REFERENCE:	Nova Bus Manuals
SECTION:	12: Seats
RS N°:	MQR 7621-2093
EFFECTIVE IN PROD.:	LD38 (2020OC)

SUBJECT:	Flip-up seats
JUSTIFICATION:	The premature failure of the grommet causes the seat backs to become loose.

CHANGE BACK PLATE ON BC55

STEP 4	STEP 5	STEP 6
RETAIN 2 SPACERS (023436307) FROM UNDER RUBBER GROMMETS/NYLON WASHERS	REMOVE FOUR BOLTS (151088001) AND TWO PLATES (162072). RETAIN THE BOLTS FOR RE-ASSEMBLY	ASSEMBLE NEW PLATE WITH ATTACHED BUMPERS (162581000) WITH FOUR BOLTS (151088001) RETAINED FROM STEP 5

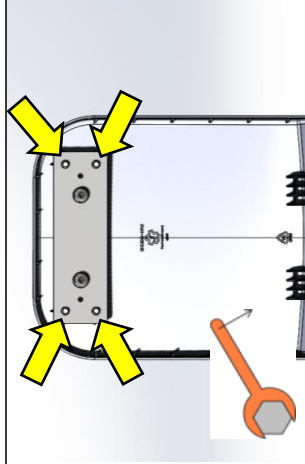
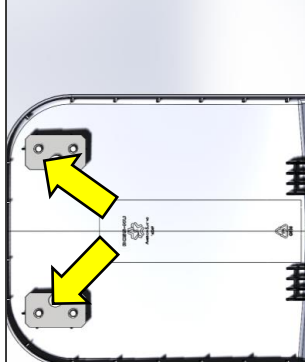
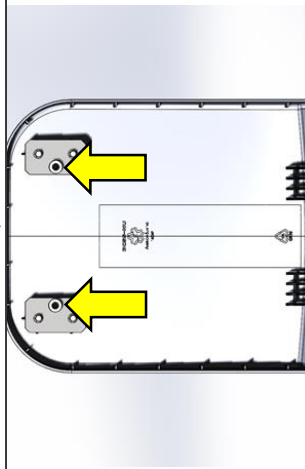
LEVEL	DESCRIPTION	DIRECT CHARGES		TIME
		LABOUR	MATERIAL	
1	Replace the two side plates by a wider plate and add rubber bumpers between the back plate and the mounting bracket.	Nova Bus	Nova Bus	6min
2	–	–	–	–

USE A 3/8" SOCKET TORQUE TO 40 IN-LBS
